REVIEW OF

HOMESTAKE MINING COMPANY

SUBMITTAL

MILAN MILL

Figure 1

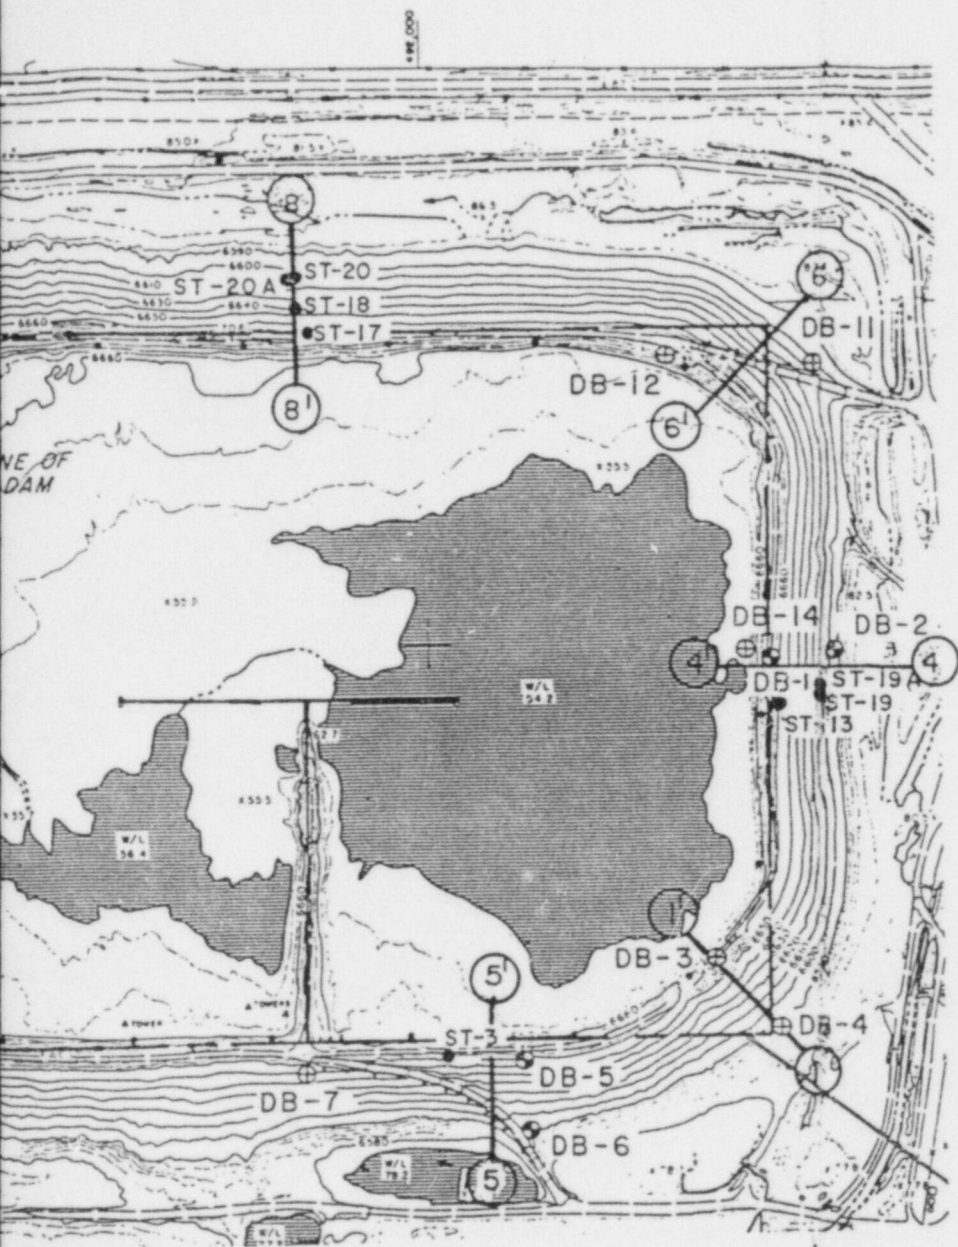
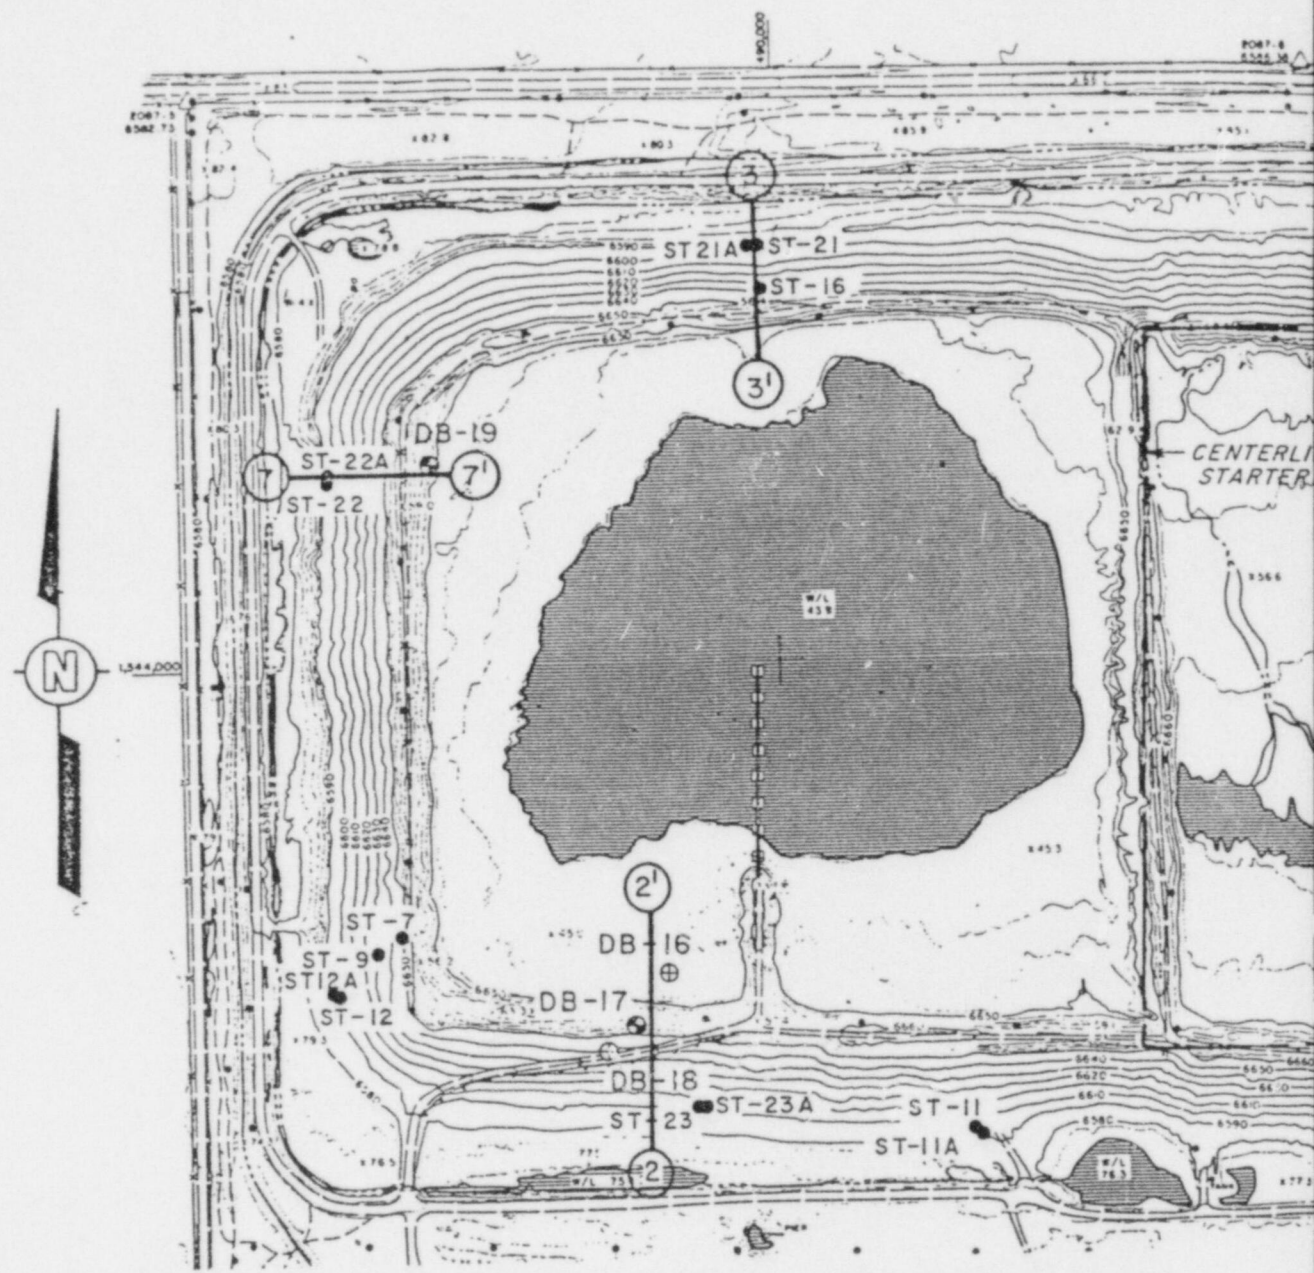
As noted in the D'Appolonia Report, stability analyses were performed on embankment cross sections taken at eight different locations (1-1' through 8-8', shown on Figure 1). Factors of safety at three locations, 1-1', 4-4', and 5-5' (Figure 1) did not meet the requirement of a 1.5 safety factor as specified in the NRC Regulatory Guide 3.11.

The phreatic level used in the stability analyses for the D'Appolonia Report was based upon piezometric measurements obtained in 1980. To monitor the phreatic surface, piezometers were installed in 1977 and in 1980 by D'Appolonia (Figure 1). The D'Appolonia Report noted that the phreatic surface within the tailings embankment did not significantly affect the safety factor until it became 50 percent greater than the piezometric level that existed in 1980. Assessments of the location of the phreatic surface have been made periodically and are kept current by Dr. Kuhn. Based upon the stability results presented in the quarterly stability report dated September 5,

Additional slope stabilization was being performed at the time of the onsite examination in the area of Section 3-3' (Figure 1), which has a relatively low factor of safety as indicated in the table above. The slope stabilization consisted of moving the crest of the embankment towards the pond, resulting in a general flattening of the slope. Based upon the stability analyses performed, this procedure does increase the factor of safety of the slope.
